4831 West Lane LLC, Local Map Amendment G-954 & Development Plan Amendment DPA 13-01

Staff Report Date: 2/25/13

Revised Proposal for Planning Board Review and Comment.

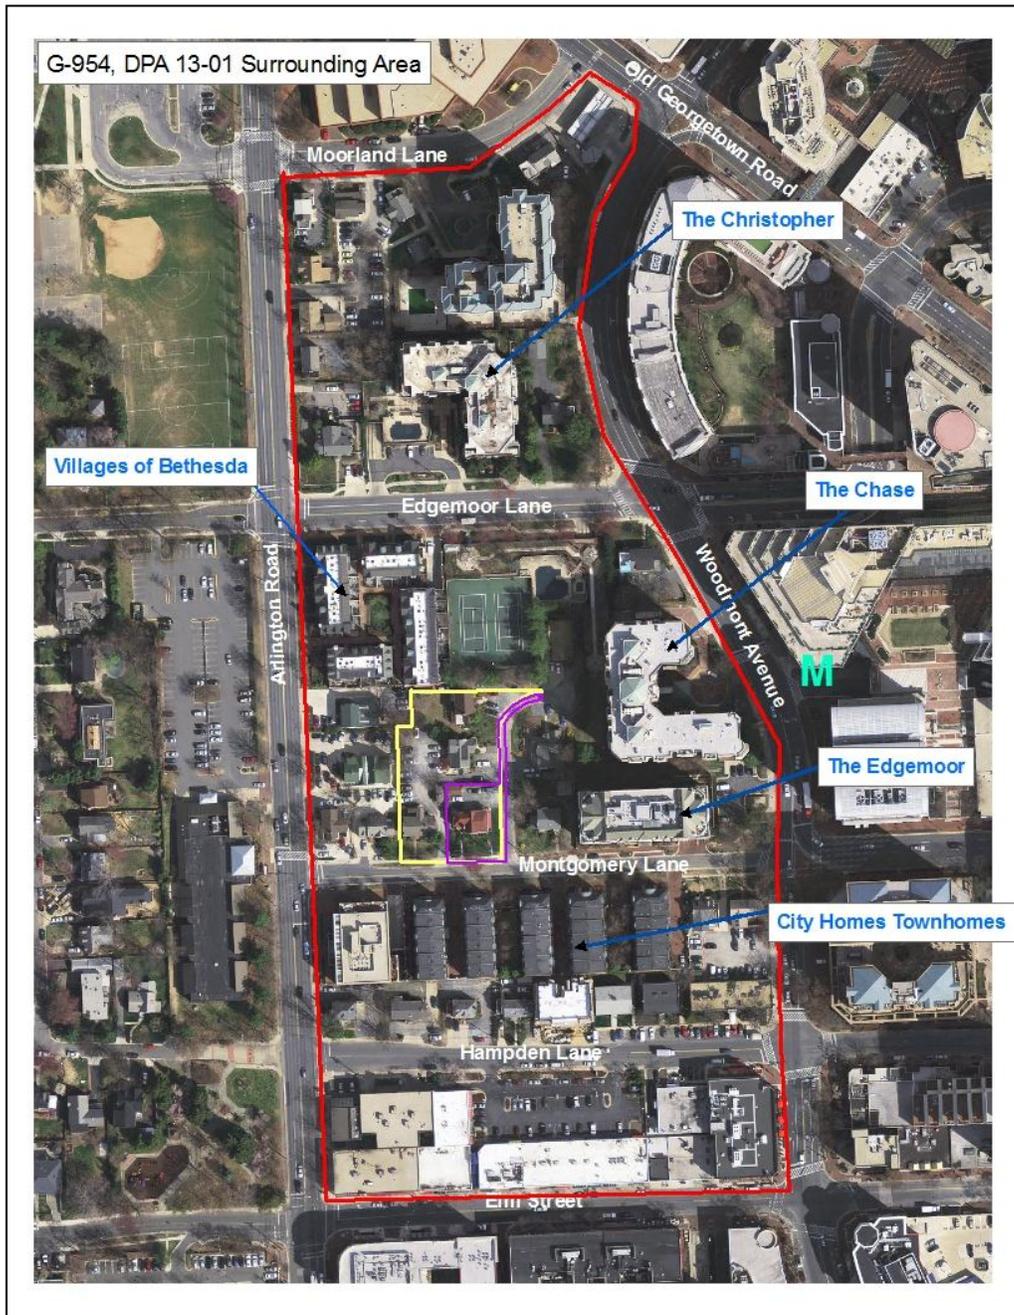
The applicant, 4831 West Lane LLC, has also submitted an application for a Development Plan Amendment to amend the development plan approved in conjunction with Zoning Application G-843 that included adjacent lots 25 and 27 and lot 24 to now include the area included in application G-954. Amending the Development Plan for the surrounding lots that were rezoned to TS-R to include the subject property of G-954 allows the applicant to request an increase in the building size of the multifamily residential building from a 48 unit, six story building to a maximum 120 unit, seven story building. The height of the building is therefore proposed to be 70 feet rather than the previously approved 65 feet. Parking for the units is provided in garage spaces located on two levels below the building, accessed from West Lane. The proposed building will have its pedestrian entrance at the corner of West Lane and Montgomery Lane. Public pedestrian access will be provided via sidewalks along both Montgomery and West Lanes.
